CDM: Recommendation Form for Small Scale Methodologies (version 01)
(To be used for presenting questions/proposals/amendments to the simplified methodologies for small-scale CDM project activity categories)

| Title/Subject (give a small title or specify the subject of your submission, maximum 200 characters): | Clarification on the applicability of AMS-III.Q to an enhanced waste heat recovery project |
| Indicative methodology to which your submission relates (refer the items of Appendix B of the Simplified Modalities and Procedures), if applicable. | AMS-III.Q “Waste Energy Recovery (gas/heat/pressure) Projects” |

The project activity is described by following diagram

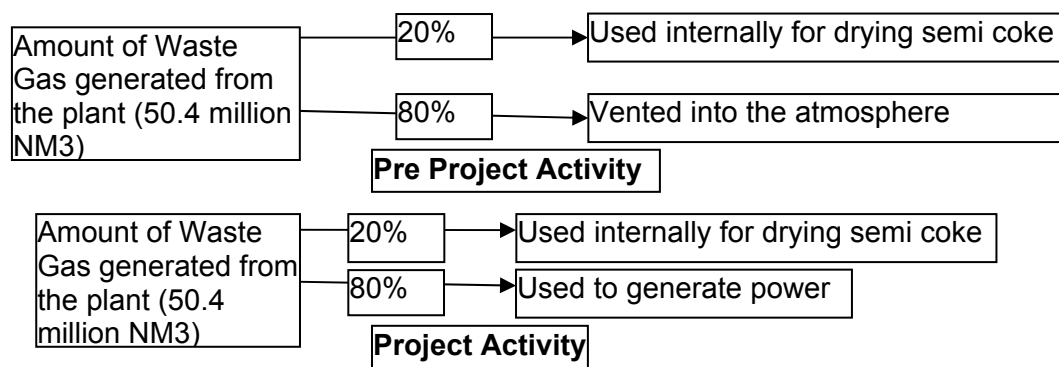
Pre Project Activity: About 50.4 Million Nm³ waste gas is generated from the semi coke oven plant. About 20% of it is used internally for drying the semi coke and the rest (80% of it) is vented into the atmosphere.

Project Activity: In the project activity the same 50.4 million Nm³ of gas will be generated from the semi coke oven plant. Among which 20% will still be used internally for drying the semi coke and the rest (80%) will be utilized to generate power.

In the pre-project activity 80% of the waste gas was emitted into the atmosphere whereas the same quantity of the waste is going to be used to generate power. The project activity is being developed under guidance of AMS IIIQ version 03. Therefore, it is required to be clarified whether AMS IIIQ version 03 is applicable using ACM 0012 version 03.2 type II equation to calculate the emission reductions. In PP's understanding Para 4 in AMS IIIQ version 03 allows this situation.

As stated in the methodology, incremental gain in an existing practice is covered in the methodology. A revision of the methodology could be proposed, in order to include correspondent equations, e.g. the ones included in ACM0012 for Type II. The project proponent also may follow the progress on the ongoing revision of ACM0012 by the Meth Panel.
